# Access Compliance Report

## Public Rights-of-Way

### (Curb Ramps)

Intersection ID: 47886	Main Street: BERKELEY PARK CT	Cross Street: PROVIDENCE RD	Location: NW
ADA ID: D81911DEDD1F	Ramp Type: Para	Initial Pass/Fail: Fail	Overall Compliance: No
Codes/Mitigation Info/Possible Solution		Field Measurements/Component Compliance	
Severity Score: 13.75

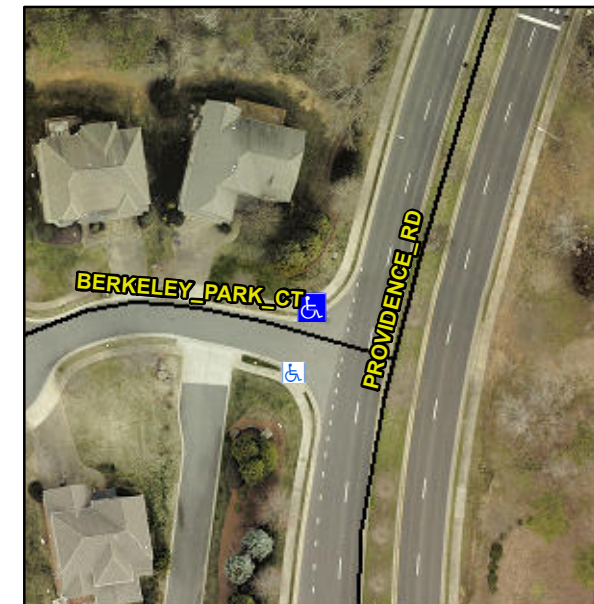
**LT RP < 5%**

**R304.5.3, R304.3.2**

Compliance	Description	Data	Compliance	Description	Data
N/A	Ramp Length LT (in)	55.0	N/A	Ramp Length RT (in)	56.0
Yes	Ramp Width LT (in)	59.5	Yes	Ramp Width RT (in)	58.5
Yes	Ramp Slope LT (%)	2.4	No	Ramp Slope RT (%)	10.0
No	Ramp XSlope LT (%)	3.6	Yes	Ramp XSlope RT (%)	0.4
N/A	Landing Length (in)	N/A	N/A	DWS Provided?	N/A
N/A	Landing Width (in)	N/A	N/A	DWS Contrast?	N/A
N/A	Landing Slope (%)	N/A	N/A	DWS Length (in)	N/A
N/A	Landing X Slope (%)	N/A	N/A	DWS Full Width?	N/A
N/A	Landing Curb? (Y/N)	N/A	N/A	DWS Offset (in)	N/A
N/A	Shared Landing?	N/A			
N/A	Gutter Ponding?	N/A	N/A	Gutter Slope (%)	N/A
N/A	Gutter Lip Ht (in)	N/A	N/A	Gutter X Slope (%)	N/A
N/A	Painted X Walk1?	No	N/A	Painted X Walk2?	N/A
	X Walk 1 Direction	To SW		X Walk 2 Direction	N/A
N/A	X Walk 1 Width (in)	N/A	N/A	X Walk 2 Width (in)	N/A
	X Walk 1 Slope (%)	2.0		X Walk 2 Slope (%)	N/A
	X Walk 1 X Slope (%)	4.8		X Walk 2 X Slope (%)	N/A
N/A	Ramp inside XWalk1?	N/A	N/A	Ramp inside XWalk2?	N/A

**Remove & Replace Entire Ramp.**
